Gas Membrane Verification Report

Verification Certificate

Lidl, Havant
Somborne Drive
Havant
PO9 5AN

GeoShield Verification Report 1

VERIFICATION LAYOUT

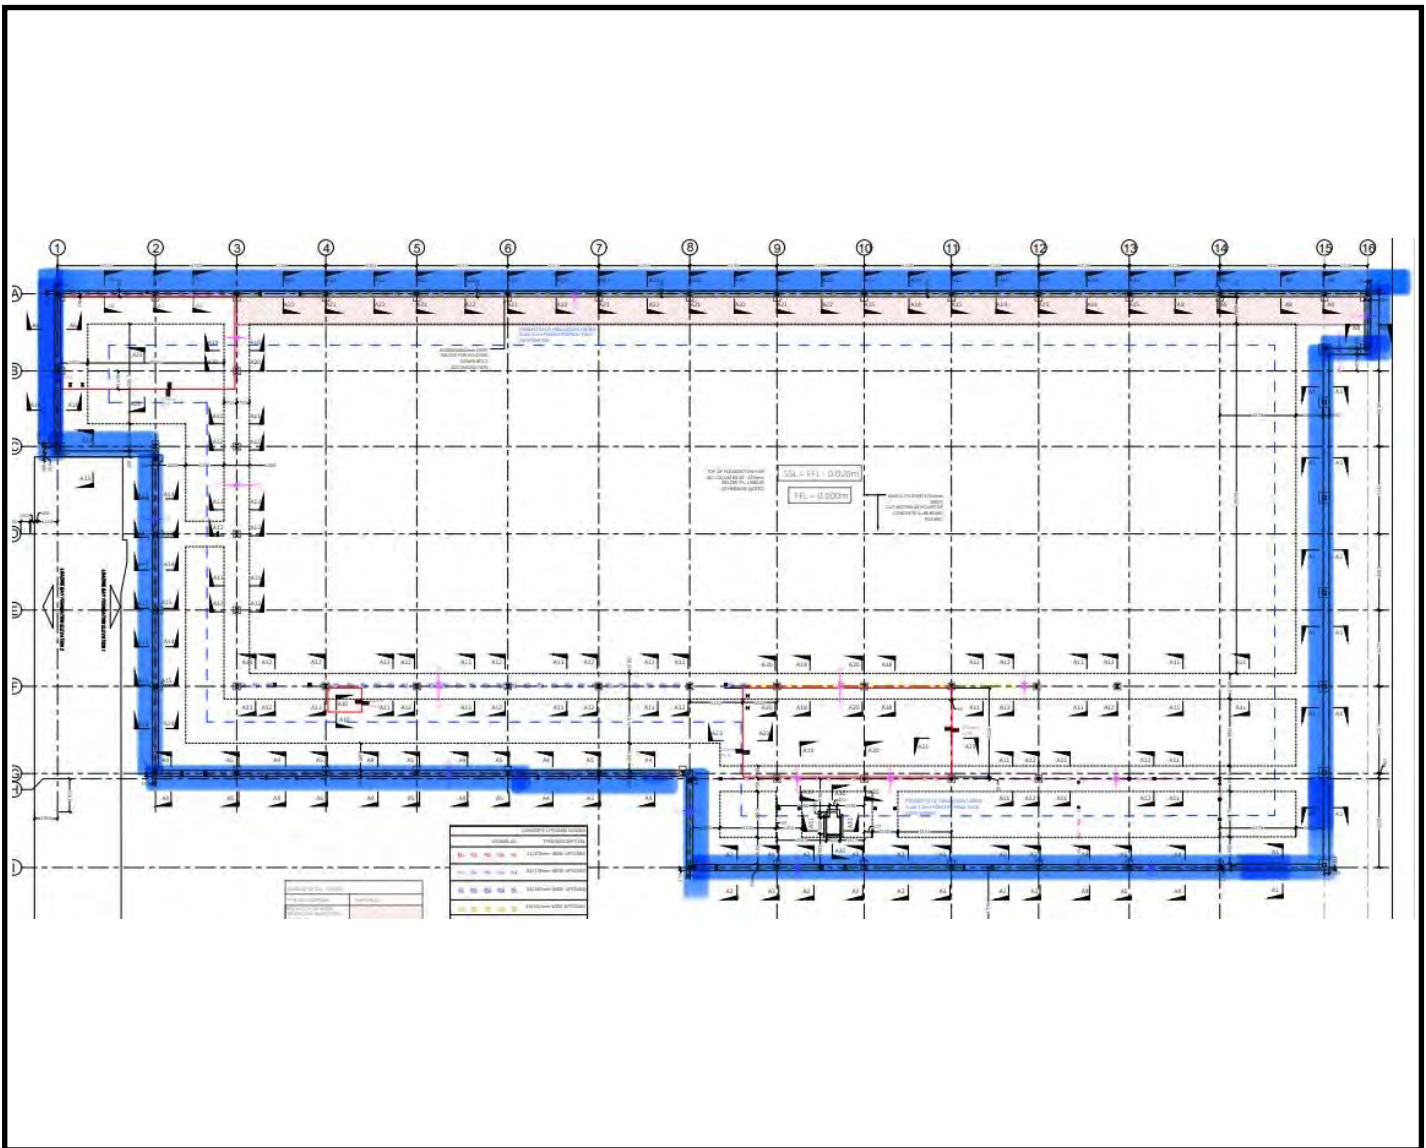
The photograph above shows a plan layout of the site. The areas highlighted in blue show the perimeter where the verification inspection took place. All areas that were previously inaccessible around the perimeters have been exposed in order that remedial work could be conducted and a further verification inspection undertaken.
